GW - 044

**GENERAL
CORRESPONDENCE**

MEMORANDUM

SUBJECT: Response to August 26, 2008, New Mexico OCD Inspection Findings:
Rambo Booster Station (former Avalon Gas Plant), former Indian Hills Gas Plant,
former Hobbs Gas Plant, Pardue Booster Station and Jackson Booster Station

OCD Rambo Photo 2

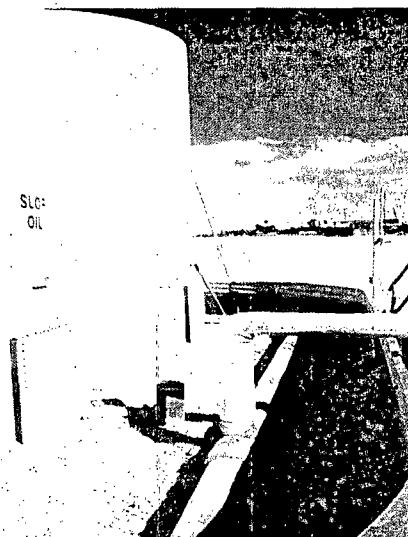
- 1) "Two ASTs had overflowed" within secondary containment and "still had residual contamination".

DCP Response: The gravel within the secondary containment has been replaced with new gravel. Please see DCP Rambo Photo 1 below.

OCD Rambo Photo 17

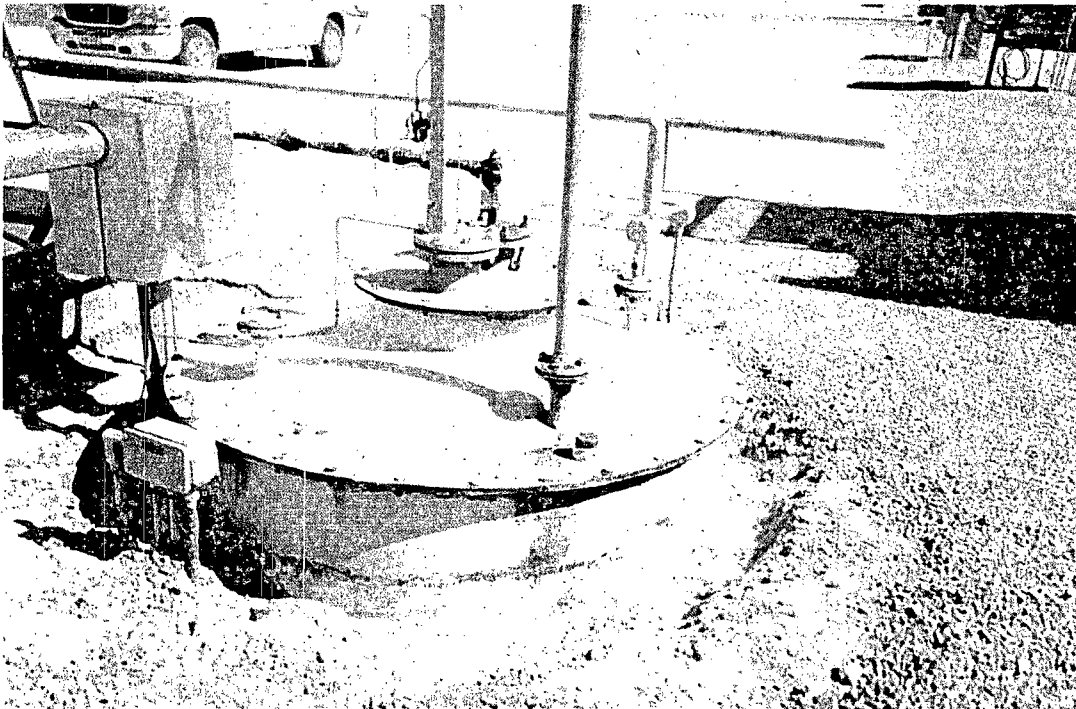
- 3) The below-grade tank had overflowed. No release report was filed with OCD.

DCP Response: Please see the DCP Rambo Photo 2 below. A release report was not filed because the release was calculated to be under the 5 barrel reporting threshold. Excavation around the sump proved that the contamination was shallow and the estimated volume released is less than 5 barrels.

OCD Photo 26

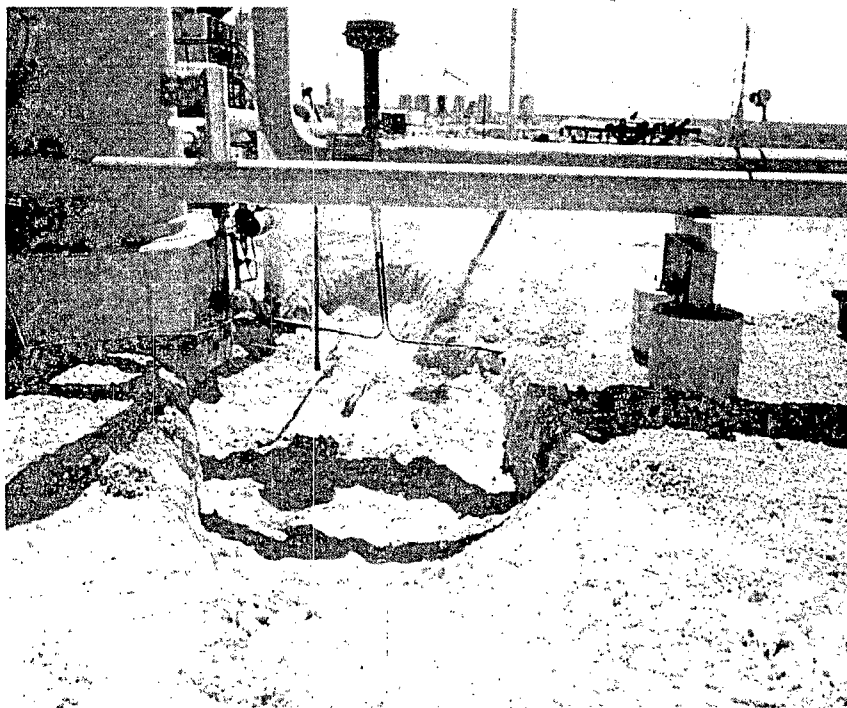
8) Discharge to the ground of "black stuff near the H₂S treater".

DCP Response: The equipment referred to is actually a scrubber. Soil and gravel around the scrubber have been removed. DCP is currently waiting confirmation sample results and will update OCD after the results are received and evaluated.

OCD Indian Hills Photo 1

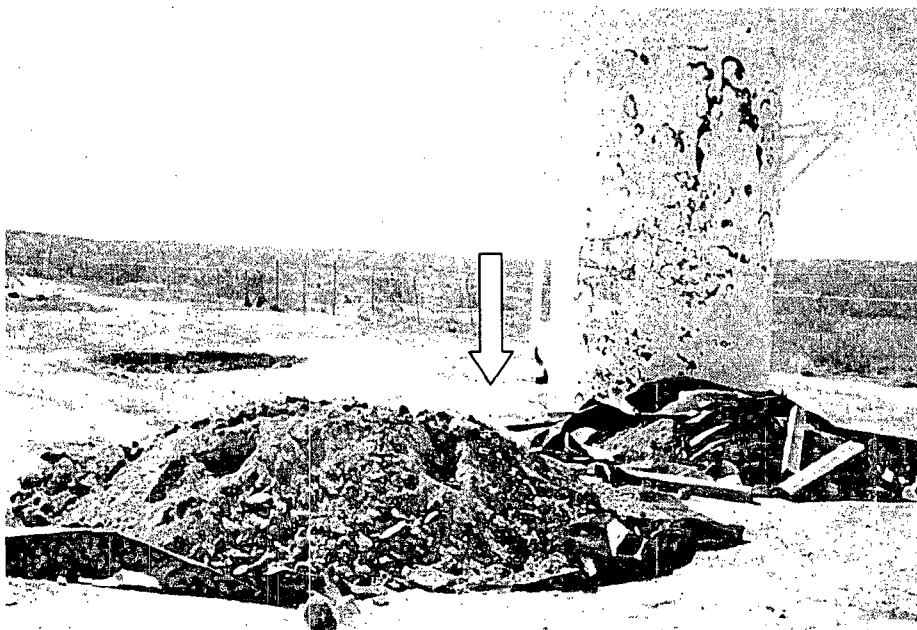
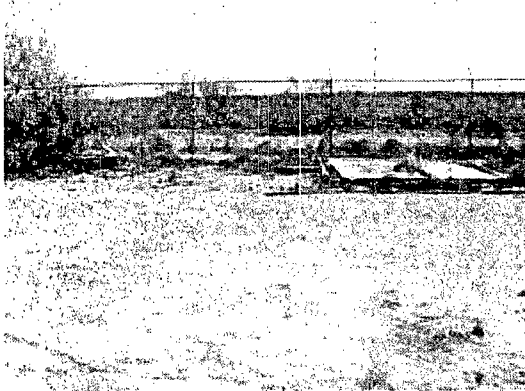
The Indian Hills Gas Plant was dismantled prior to ownership by DCP and its predecessor companies. Only a meter facility, an active gas pipeline, and pig launcher currently exist at the site. OCD was notified of the facility status on 12/10/01 and requested a closure plan, prior to the 8/16/08 site inspection. After the inspection, OCD provided the following statement: "At the time of inspection the site was not viewed to be closed due to the findings." The two OCD findings were: 1) "Significant equipment remains on site, i.e., tanks and underground piping. Removal needed"; and 2) "One area of small surface contamination was noticed from an unused AST that should be cleaned up".

DCP has removed the contaminated soil near the base of the AST (OCD Indian Hills Photo 1). An additional area of stained soil was also removed. Please see DCP photo 1. When the tanks are removed, any stained soil beneath the tanks will be sampled to determine if there is any hydrocarbon contamination above OCD cleanup levels. Soils with hydrocarbon contamination higher than OCD cleanup levels will be removed. Additionally, DCP is in the process of removing the debris from the fence, noted in OCD Indian Hills Photo 7.

OCD Rambo Photo 17

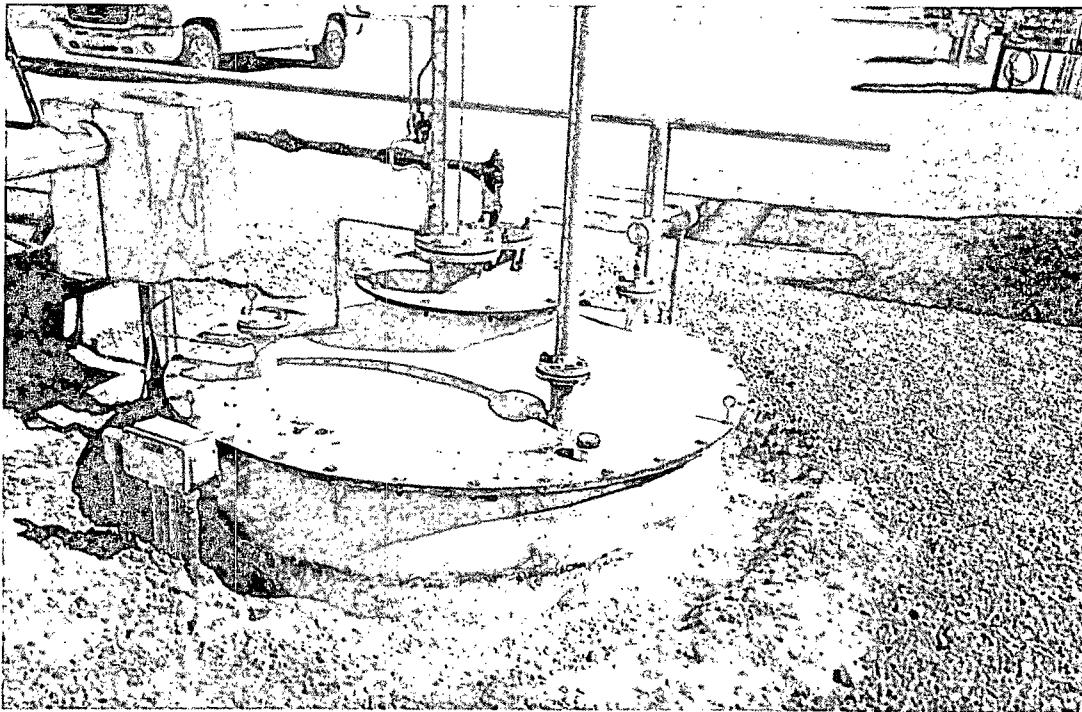
3) The below-grade tank had overflowed. No release report was filed with OCD.

DCP Response: Please see the DCP Rambo Photo 2 below. A release report was not filed because the release was calculated to be under the 5 barrel reporting threshold. Excavation around the sump proved that the contamination was shallow and the estimated volume released is less than 5 barrels.

OCD Photo 26

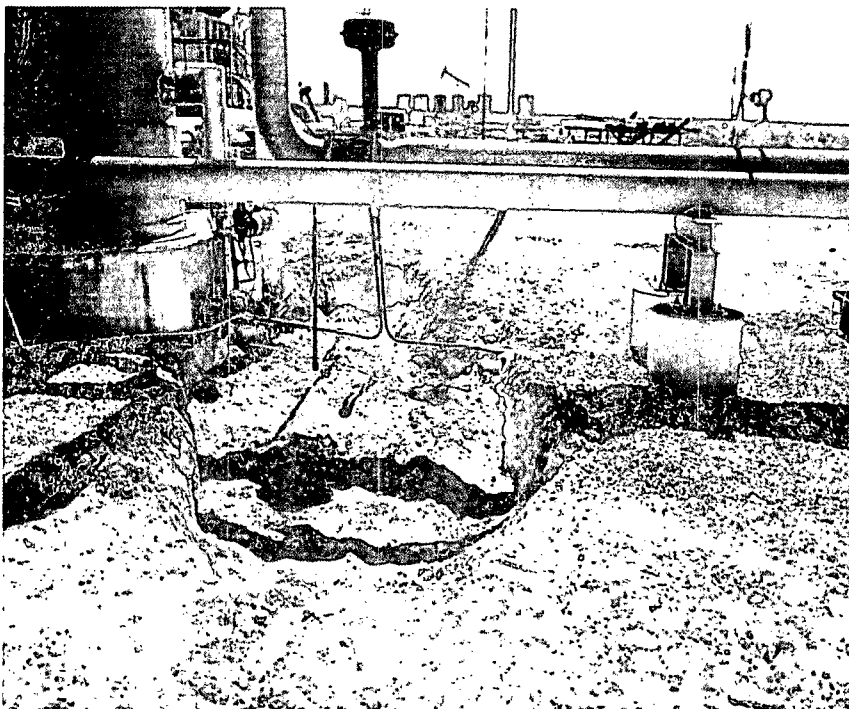
- 8) Discharge to the ground of "black stuff near the H₂S treater".

DCP Response: The equipment referred to is actually a scrubber. Soil and gravel around the scrubber have been removed. DCP is currently waiting confirmation sample results and will update OCD after the results are received and evaluated.

OCD Indian Hills Photo 1

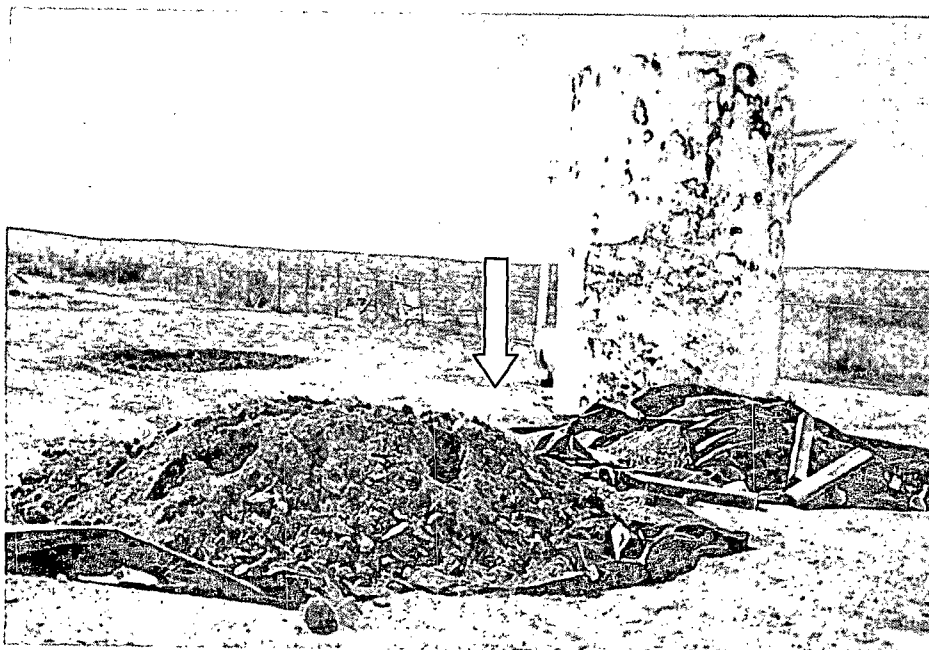
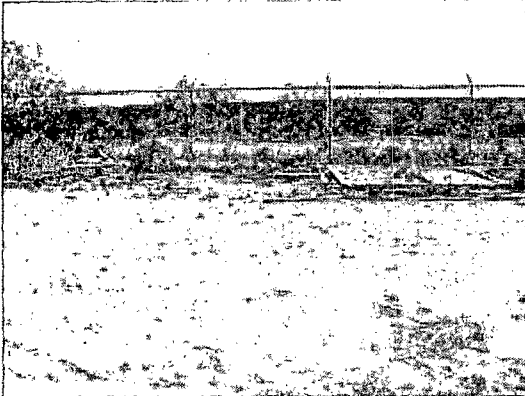
The Indian Hills Gas Plant was dismantled prior to ownership by DCP and it's predecessor companies. Only a meter facility, an active gas pipeline, and pig launcher currently exist at the site. OCD was notified of the facility status on 12/10/01 and requested a closure plan, prior to the 8/16/08 site inspection. After the inspection, OCD provided the following statement: "At the time of inspection the site was not viewed to be closed due to the findings." The two OCD findings were: 1) "Significant equipment remains on site, i.e., tanks and underground piping. Removal needed"; and 2) "One area of small surface contamination was noticed from an unused AST that should be cleaned up".

DCP has removed the contaminated soil near the base of the AST (OCD Indian Hills Photo 1). An additional area of stained soil was also removed. Please see DCP photo 1. When the tanks are removed, any stained soil beneath the tanks will be sampled to determine if there is any hydrocarbon contamination above OCD cleanup levels. Soils with hydrocarbon contamination higher than OCD cleanup levels will be removed. Additionally, DCP is in the process of removing the debris from the fence, noted in OCD Indian Hills Photo 7.

OCD Pardue Photo 6

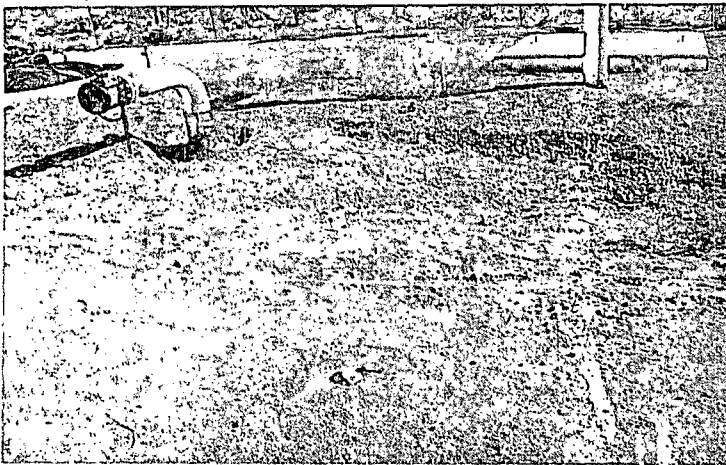
A permit renewal application was approved by OCD but DCP then chose to close the facility instead and terminate the permit renewal process. Prior to the 8/26/08 site inspection, OCD anticipated that DCP would submit a closure plan. OCD inspected this facility as part of its determination of eligibility of closure. During the inspection, the inspector noted: 1) Some equipment remains on site that needs to be removed; and 2) One small area of surface contamination needs to be cleaned up. DCP committed to renew the discharge permit. OCD has inquired if DCP intends to reactivate this site in the future.

DCP Response: DCP has determined that the facility could be reactivated and therefore chooses to retain the equipment on site. DCP has removed the area of surface contamination (see DCP Pardue Photo 1 below) and is currently awaiting analytical results from confirmation sampling. DCP will update OCD when the analytical data is received and evaluated and wants to complete the discharge permit renewal process for this facility.
